Variant name: TE0803-03-4BI61-X

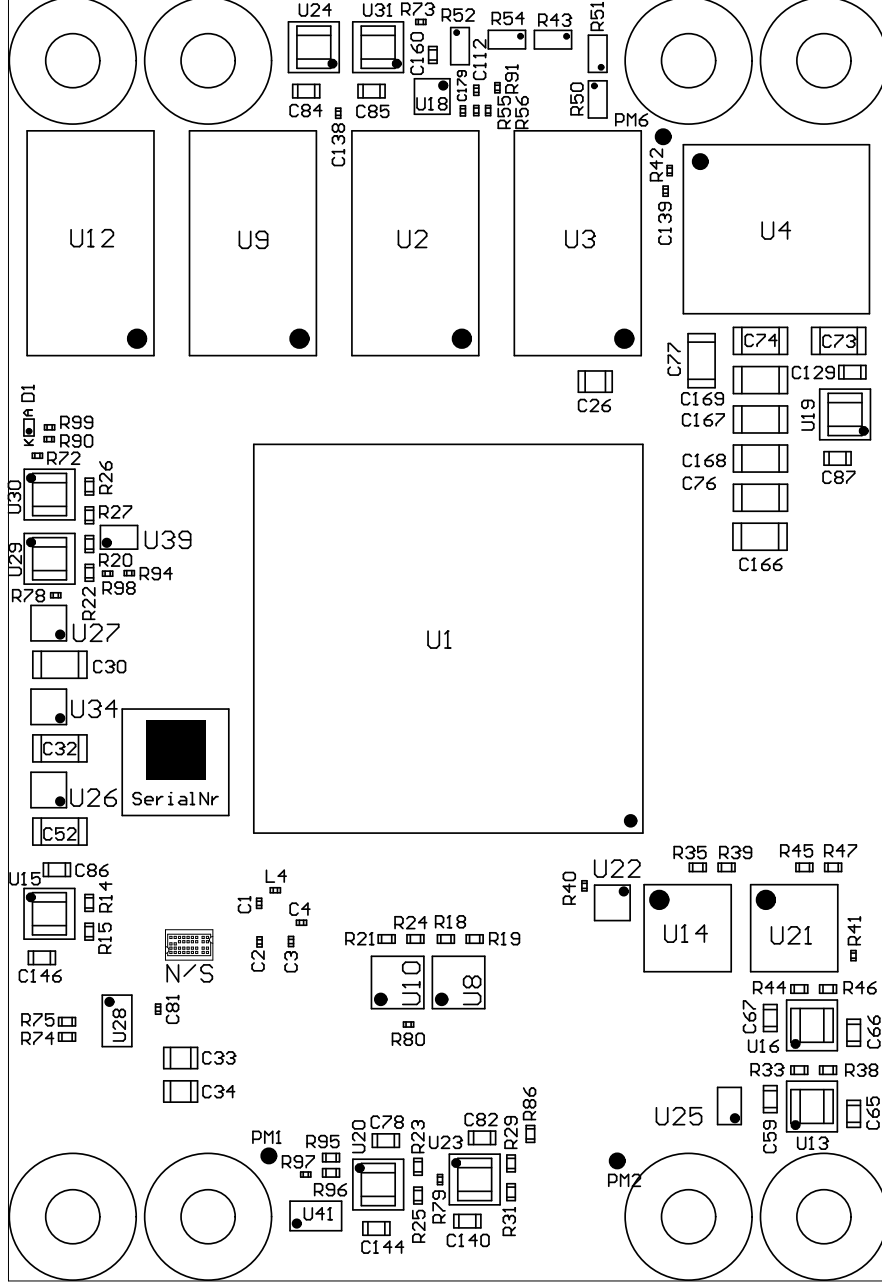
U41 Power supervisor TPS3106K33DBVR replaced by Schottky diodes SBAS70-04LT1G
